Detailed Site Plan
Departure from Design Standards
Alternative Compliance
The Herman Apartments

DSP-22017
DDS-24003
AC-25009

STAFF REPORT

SUBJECT: Detailed Site Plan DSP-22017
Departure from Design Standards DDS-24003
Alternative Compliance AC-25009
Type 2 Tree Conservation Plan TCP2-023-2025
Variance to Section 27-442(c)
The Herman Apartments

Figure 1: Site Plan

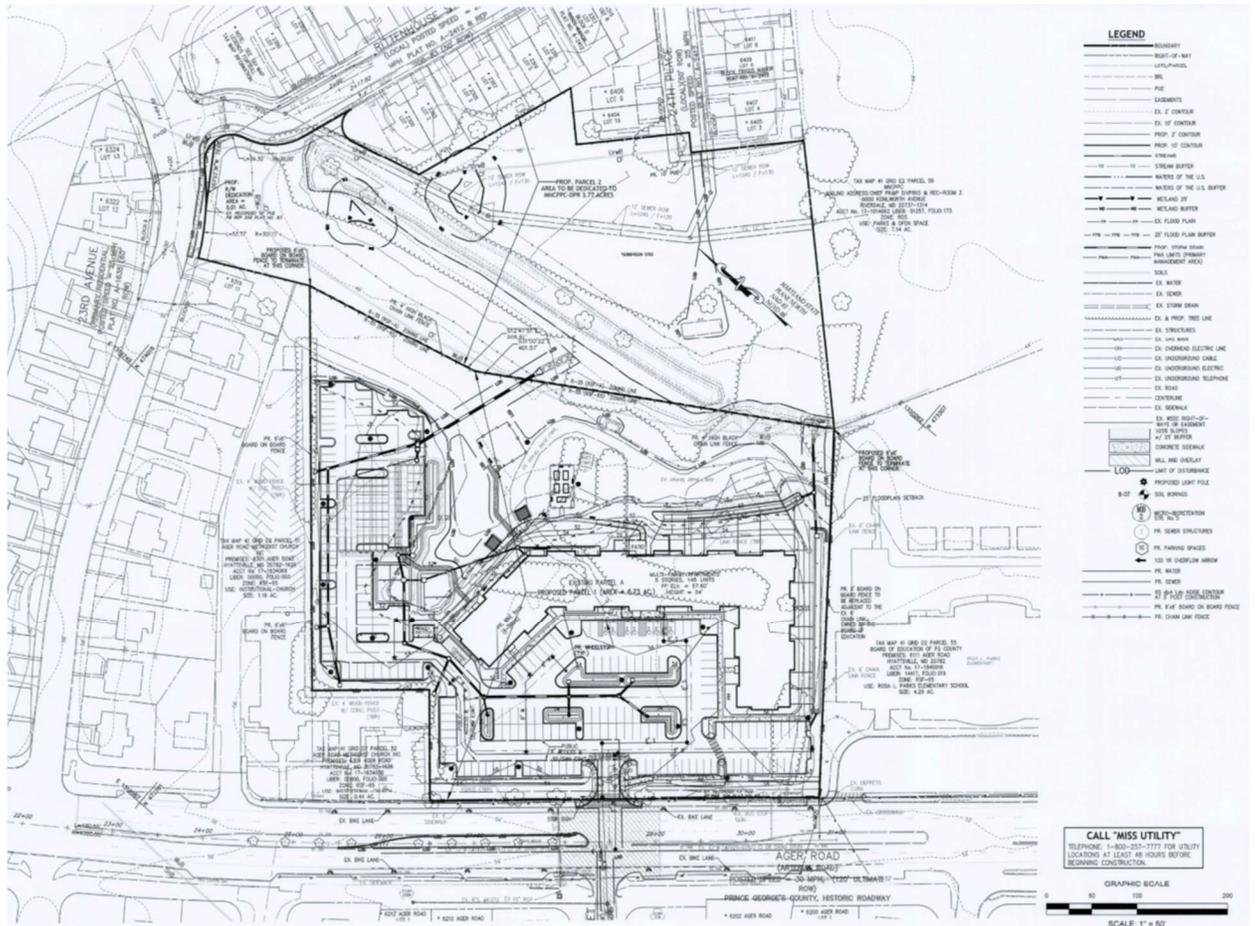
**Two variances are requested with this DSP, as discussed below in Finding 7.e. The variances seek a 22 percent increase in the maximum percentage of net lot coverage, from 40 to 62 percent, and a 22 percent decrease in minimum percentage of green area, from 60 to 38 percent. A green area exhibit was submitted to show the area that is counted, which contains some technical errors. A condition is included herein requiring the applicant to revise the green area exhibit to distinguish floodplain areas from green areas, and to change the legend from “pervious areas” to “green areas” on the plan.

***In addition to the two regulations from which a variance is requested, the front, side, and rear yard setbacks provided in the schedule on the plan do not reflect the actual distances provided. A condition is included herein requiring the applicant to update the schedule on the cover sheet, to reflect the actual yards provided to demonstrate conformance, and to remove the note with two asterisks which states “if the buildings are more than 36 feet high, 4 or more stories, and has an elevator”.

The submitted parking schedule shows the parking requirement is met. However, there is a technical error in the parking schedule. A condition is included herein requiring the applicant to revise the parking schedule by placing the electric vehicle spaces row above the total spaces provided row, ensuring a total of 223 parking spaces.

Figure 5: Floodplain acreage comparison with surrounding properties

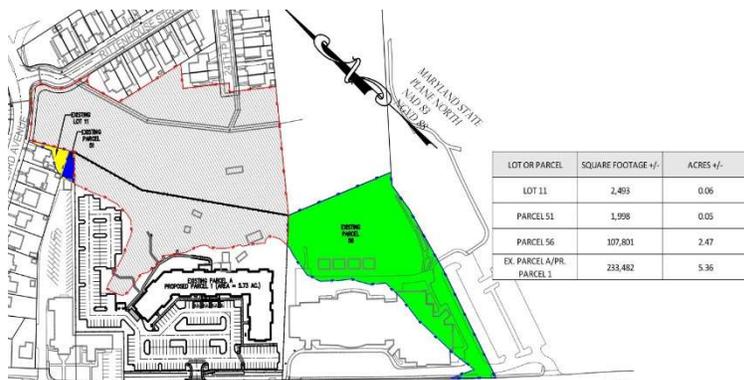
The applicant further provides a graphic showing the area of floodplain on the subject property (outlined in red), compared to the floodplain area on neighboring properties (shown in green, blue, and yellow).

DEPARTURE FROM DESIGN STANDARDS DDS-24003

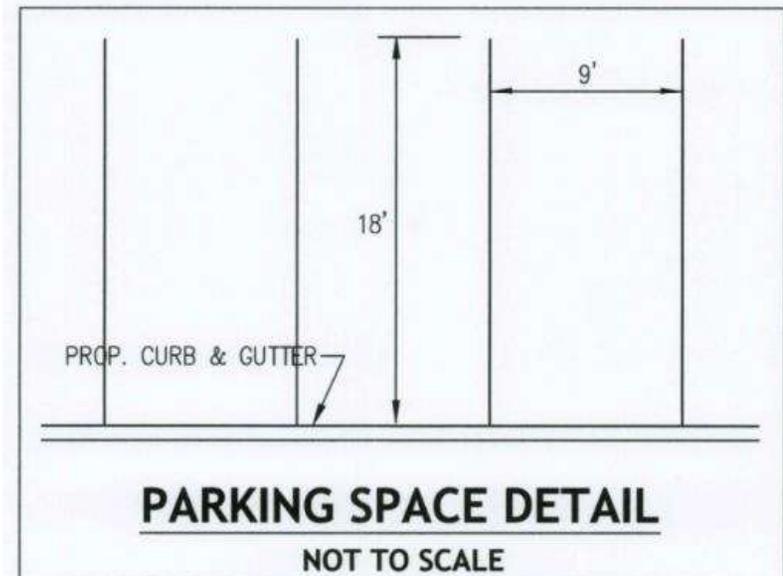
Notes: *Departure from Design Standards DDS-24003 is submitted with this DSP for approval, which is addressed below in Finding 7.d. DDS-24003 seeks a reduction of the required parking space size (9.5 feet by 19 feet) to 9 feet by 18 feet. However, the typical parking space detail still shows a size of 9.5 feet by 19 feet, and the parking departure application number is incorrect. A condition is included herein requiring the applicant to remove the typical parking space detail exhibit, which shows typical parking space size as 9.5 feet by 19 feet, and revise the parking space detail exhibit by showing the correct parking departure application number.
